Subject: RE: O8W-PM 35217268, 35224712, 35224713 - Bucks Creek 1101 Phase 1,2&3 - Pre-Engineering Meeting

Bucks Creek 1101- PM# 35217268

PM 35217268 (Phase 1)

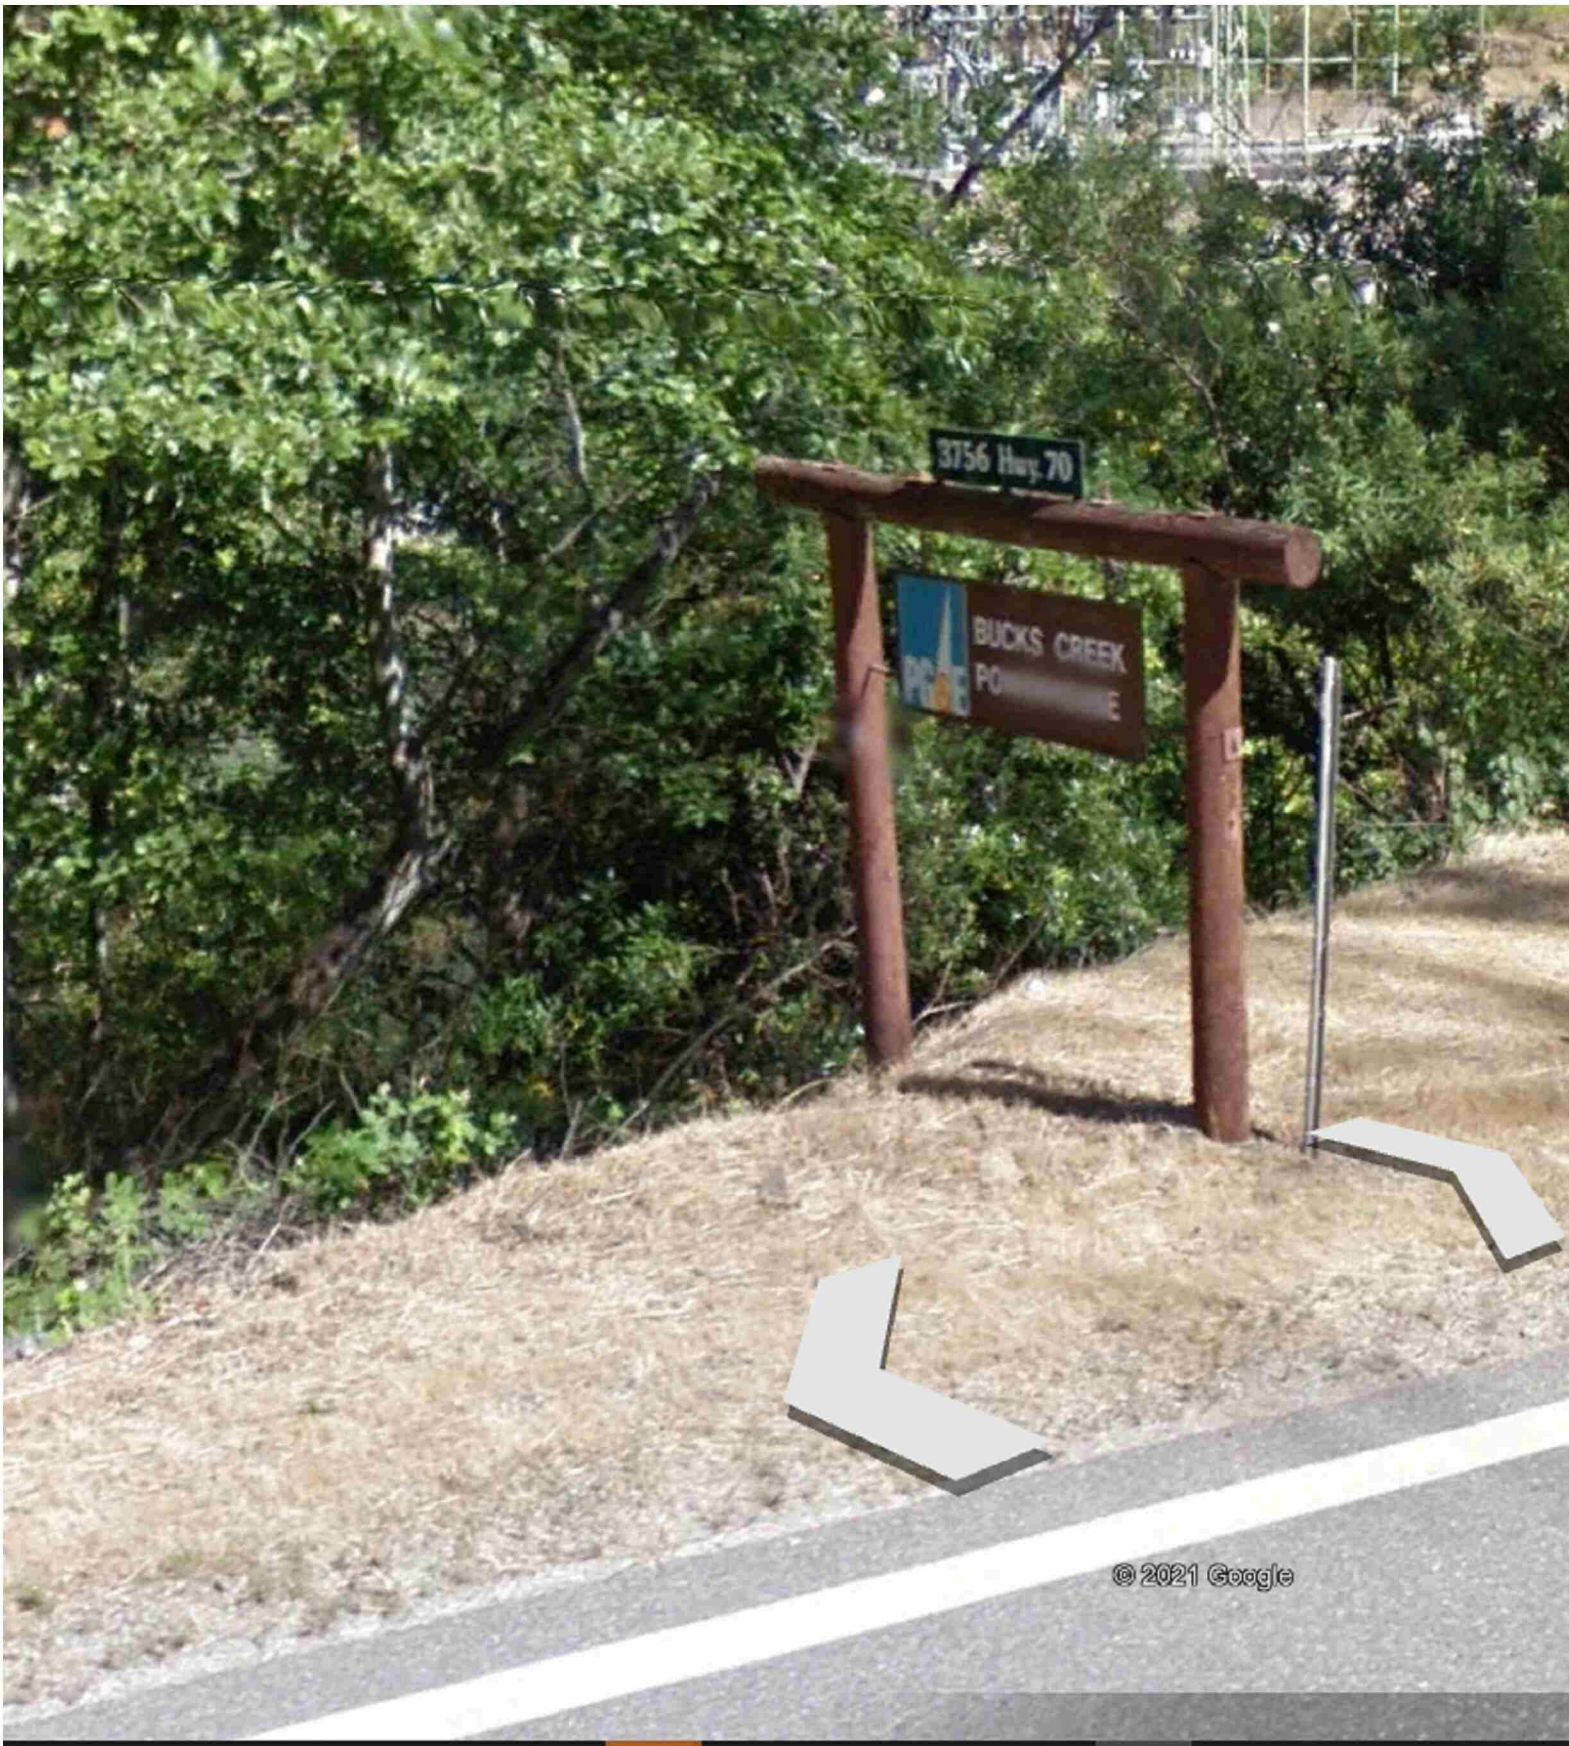
Attached are the 'base-map' limits in a kmz. file. As you will see, we need our base-map to go about ~100' into the tunnel at the south end (see pedestal in picture below... please begin about ~50 beyond this point which is about ~100' beyond the Cresta Dam).

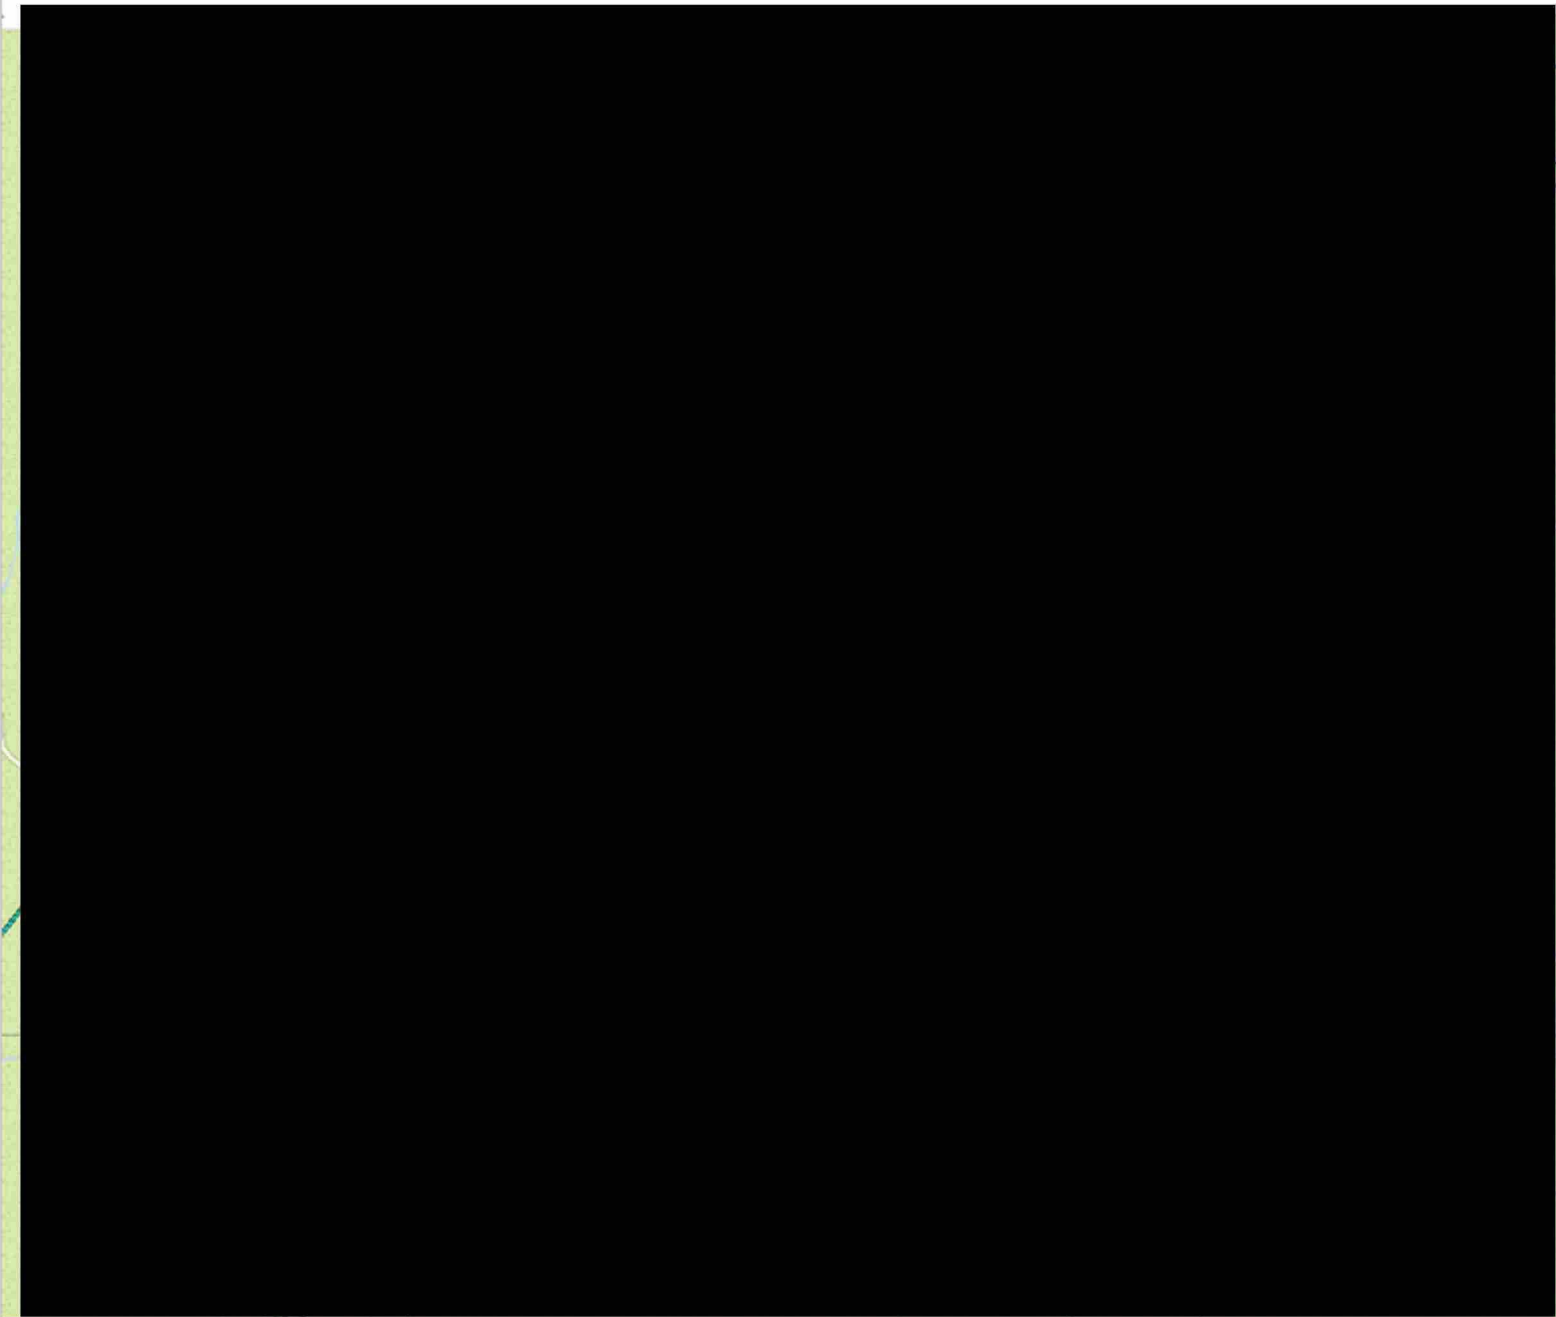
We want to end the base-map at the sign location below which is roughly at MM (Mile Marker) 5.10.
